ADDENDUM NO. 2

JUNE 15, 2026

PREPARED BY SCHMIDT ASSOCIATES FOR:
BLOOMINGTON CONVENTION CENTER WAYFINDING & SIGNAGE
BLOOMINGTON CONVENTION CENTER

MONUMENT SIGN

WF-401

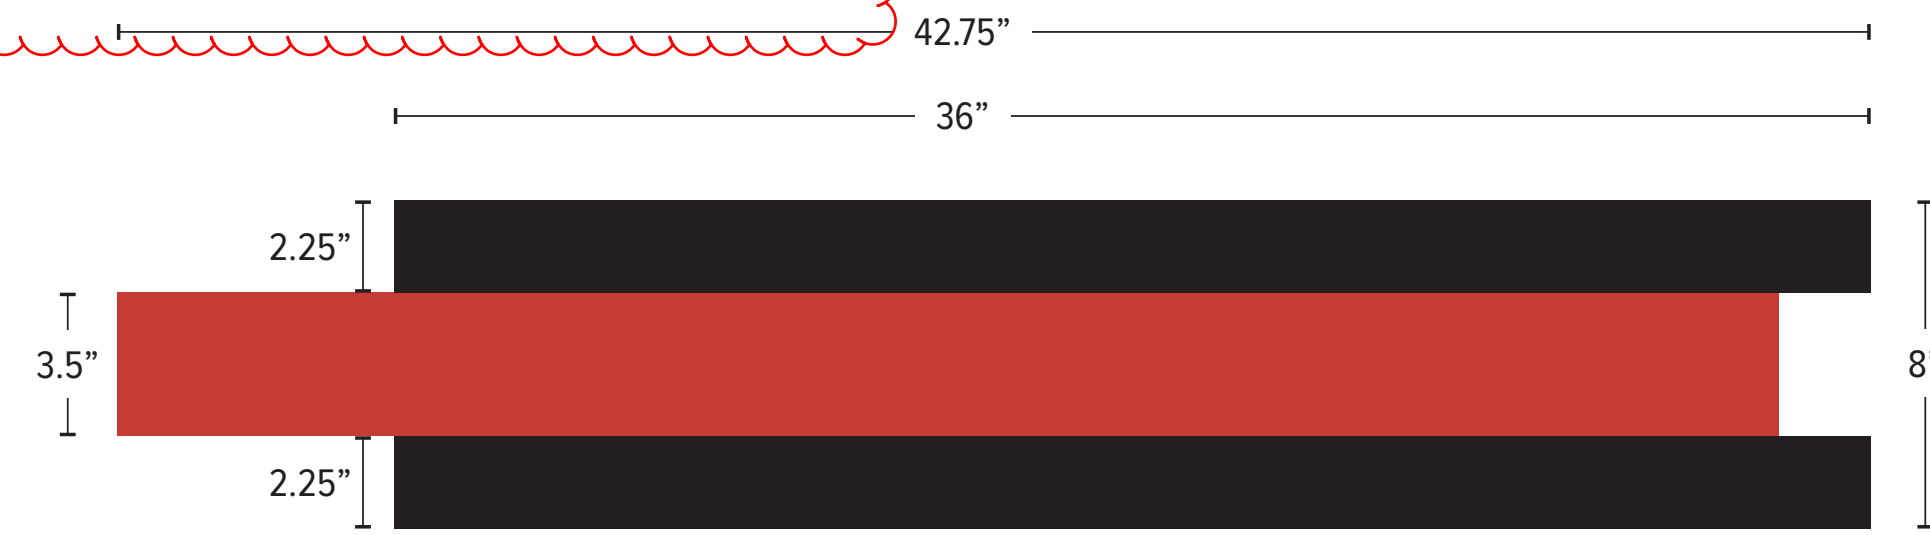
- Sign structure to be fabricated aluminum monument assembly with integrated red and black metal panel system and recessed digital display.
- Sign face to be formed aluminum panels with matte black finish and gloss red accent panel. Total panel depth to be 8". Black panel field to project 2.25" with red accent inset flush at 3.5" within assembly.

- Overall sign dimensions to be 72" height including base, with 65" sign body and 7" base. Sign width to be 45.5". Base depth to be 10".
- Top of sign to be sloped down at a 7-degree angle with continuous metal cap.

- All metal panels to be minimum 0.125" aluminum with high-performance exterior paint or powder-coated finish. Black panel to be matte/satin finish. Red panel to be gloss finish.

- Internal structure to be welded aluminum or steel frame engineered for exterior conditions.
- All edges of sign to be straight with square corners unless noted. Panel joints to be tight and aligned. Fasteners to be concealed or color-matched.

- Sign to be mounted to concrete footing with concealed anchor system. Coordinate structural support and footing design - delegated design
- Contractor to verify all dimensions and field conditions prior to fabrication. Signage to comply with applicable local codes.

• Remove existing monument sign. Restore all adjacent disturbed materials to original condition after installation of new sign. Provide and install three bushes behind the new sign, matching the existing bushes in size, type, and overall appearance.
